Subject: Groundwater Monitoring Plan
FAA Oakland TRACON Facility

Advanced Sciences, Inc. (ASI) is pleased to present a proposed well installation and groundwater monitoring plan with a schedule for a suspected spillage of diesel near a former underground diesel tank at the Federal Aviation Administration (FAA) Oakland Airport Terminal Radar Approach Control (TRACON) facility. Analytical results of a soil sample collected during the removal of the underground tank indicated a total petroleum hydrocarbon (TPH) concentration above the Alameda County Department of Environmental Health (DEH) recommended cleanup level of 100 milligrams per kilogram (mg/kg) in the tank backfill soil, though this sample may be invalid. TPH concentrations also were detected in groundwater beneath the tank. To obtain regulatory site closure, the FAA must demonstrate low or nondetectable concentrations of TPH in the tank backfill soil and that TPH concentrations detected in the groundwater are not related to the FAA tank. This proposal addresses soil sampling and analysis within the former tank backfill and the installation of up to three monitoring wells at the site with groundwater sampling and analysis in

Proposed Exploration Locations
Federal Aviation Administration
Oakland TRACON Facility
Site Investigation Proposal

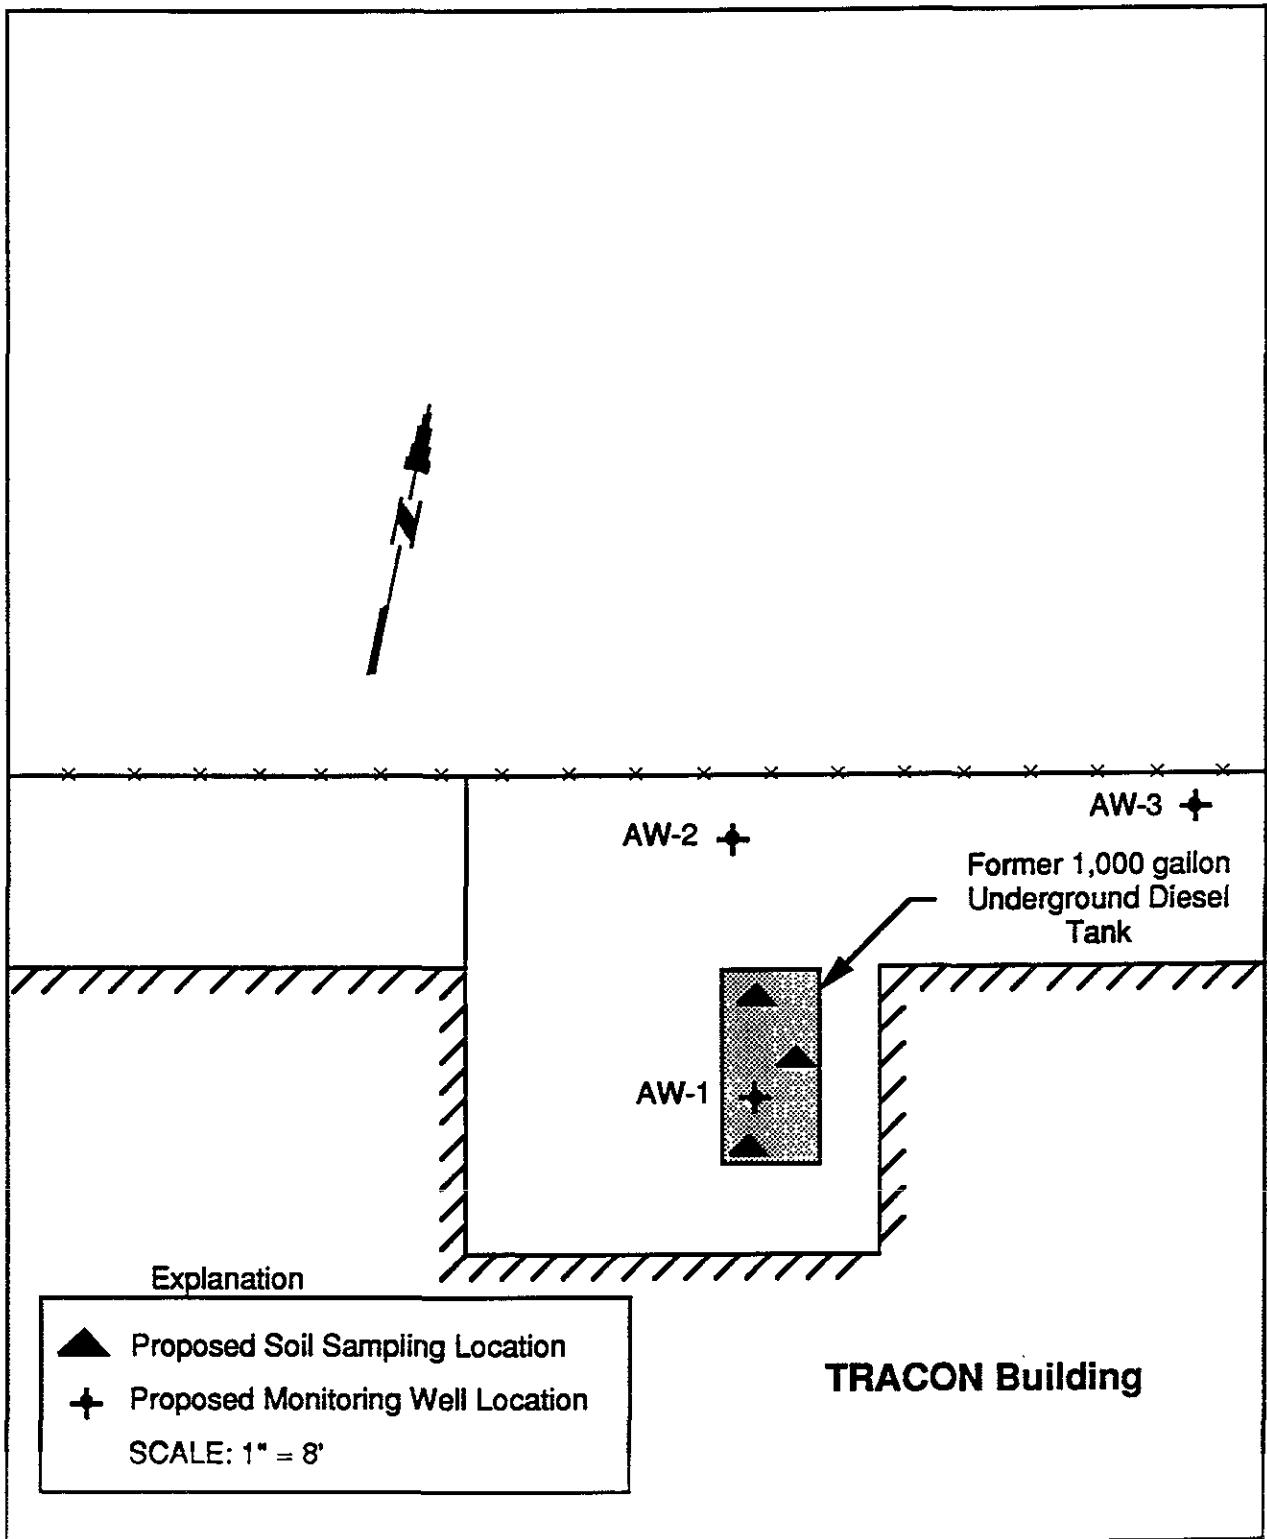
Should collect samples at 7' or deeper
